**Service Action SP1080: PS3 Tailgate Leakage
Model Year 2025 Polestar 3**

GROUP: 83	NO: SP1080	ISSUING DEPARTMENT: Product, Safety and Compliance	CAR MARKET: United States	
REVISIONS:			ISSUE DATE: 2026-02-13	STATUS DATE: 2026-02-18
Page 1 of 6

Title	Tailgate/trunk lid panel	Page	1 (3)
Action	Adjustment	Operation number:	99924-2

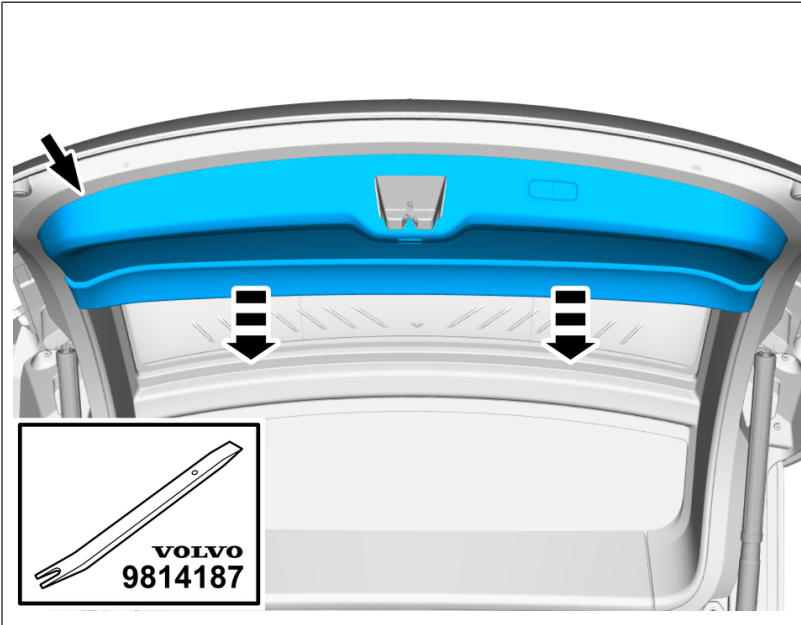
The concern with the tailgate is that 5 holes are drilled and not resealed which may cause water intrusion into the tailgate.

In the instruction inside of the cavity where it is marked for sealing, there you will see 1 drilled hole around 6mm in diameter that needs to be covered.

In the instruction inside of the cavity where it is marked for sealing, there you will see 1 drilled hole around 6mm in diameter that needs to be covered.
Example photos below:
